Customer	: CU-DAR001 Dart Helicopters Services	Drawing Name	: HELI UTILITY BASKET LH/RH 350/355
Job Number	: 31504		
Estimate Number	: 10208		
P.O. Number	: N/A	Part Number	: D350607043
This Issue	: 3/26/2007 S.O. No. : N/A	Drawing Number	: D350-607 REV F P7-9
Prsht Rev.	: NC	Project Number	: N/A
First Issue	: N/A Type : LARGE FAB ASSY	Drawing Revision	: F
Previous Run	: 31472	Material	: N/A
Written By	: <u>JA</u>	Due Date	: 4/15/2007 Qty: 1 Um: Each
Checked & Approved By	: <u>03.27</u>		
Comment	: Est Rev:E as Per DSI9318 06-01-24 JLM

DESIGN <i>CP</i>	DRAWN BY <i>CP</i>	DART AEROSPACE LTD HAWKESBURY, ONTARIO, CANADA	
CHECKED <i>[Signature]</i>	APPROVED <i>[Signature]</i>	DRAWING NO. DSI 9318	REV. A SHEET 1 OF 1
DATE 06.01.06		TITLE WASHER ADDITION	SCALE NTS
A	06.01.06	NEW ISSUE

DART SERVICE INSTRUCTION

TO AMEND INSTALLATION INSTRUCTIONS D350-607 REV. F

Figure 5- Basket Replacement Parts
(D350-607-043 Heli-Utility-Basket™)

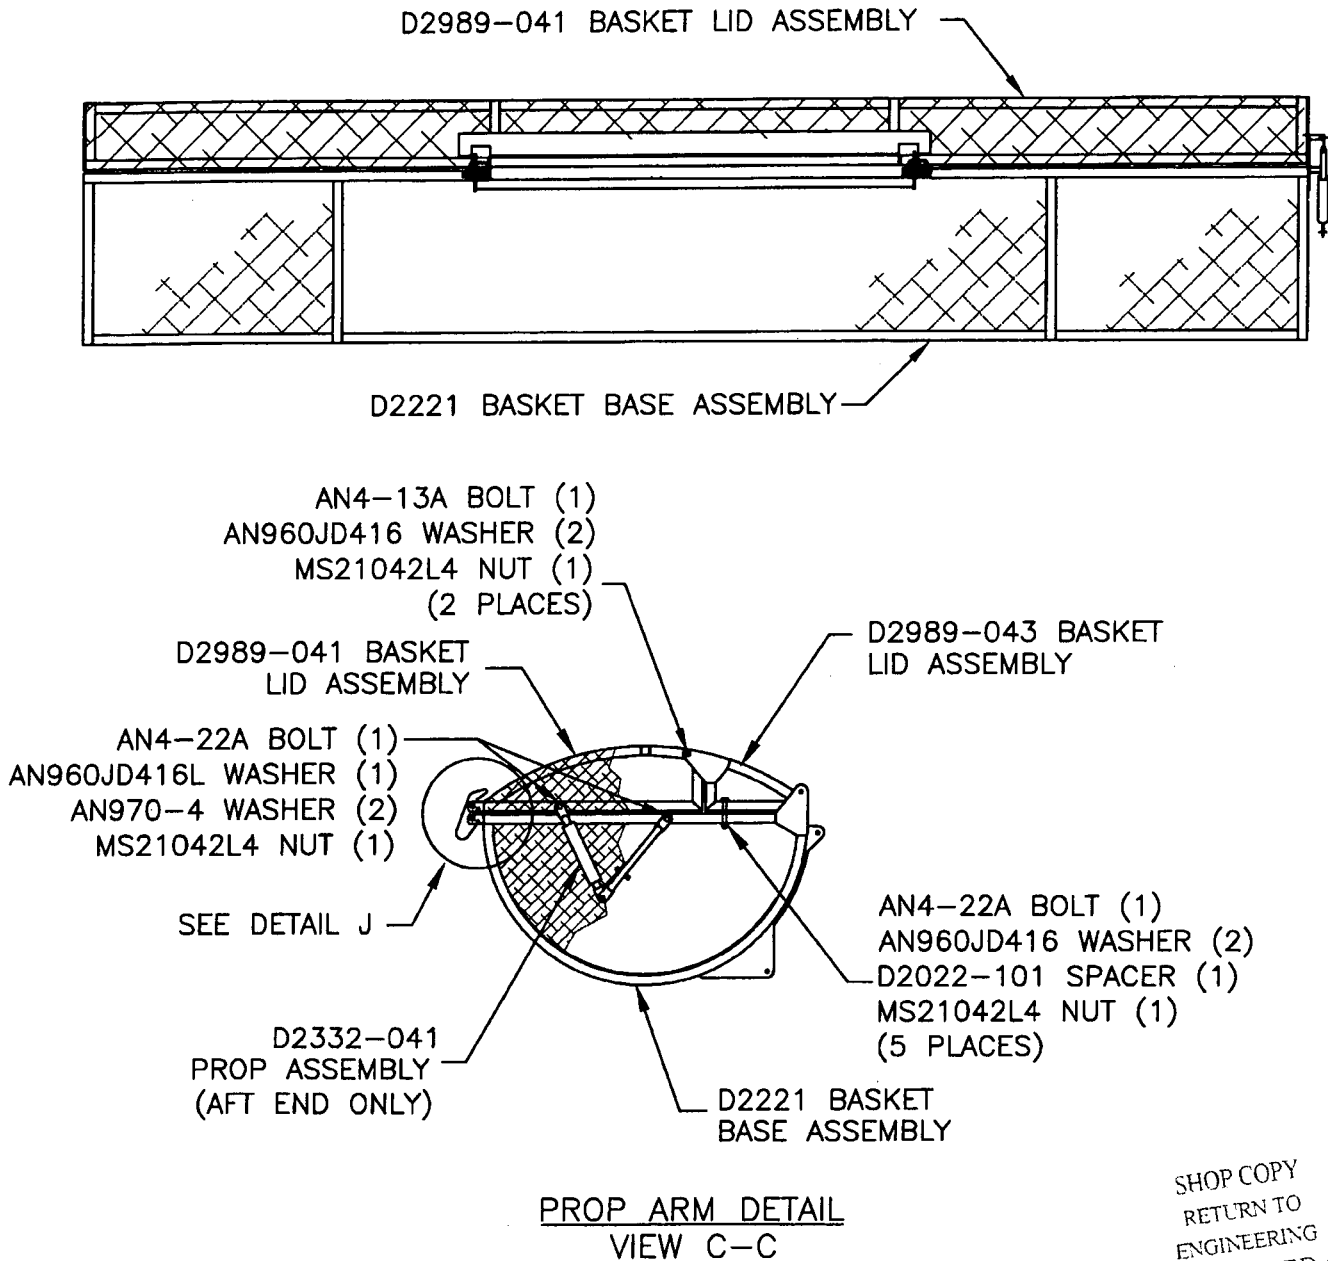
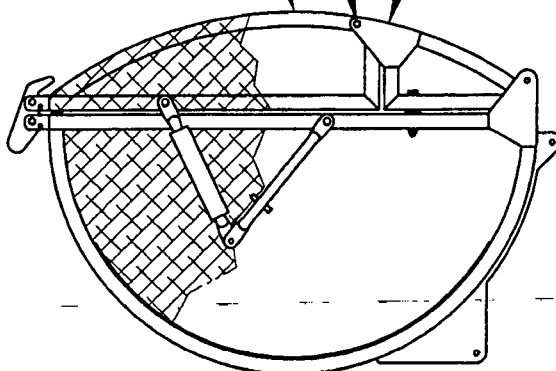
To reduce the possibility of damaging the finish, a **NAS1515H4** washer (2 places) has been added between the hinge plate and basket frame on the **D350-607-043/-047 Heli-Utility-Basket**.

The corrected bolt stackup from Figure 5 of installation instructions D350-607 Rev. F is given below:

AN4-13A BOLT (1)
AN960JD416 WASHER (1)
HINGE PLATE (REF)
NAS1515H4 WASHER (1)
BASKET FRAME (REF)
AN960JD416 WASHER (1)
MS21042L4 NUT (1)
(2 PLACES)
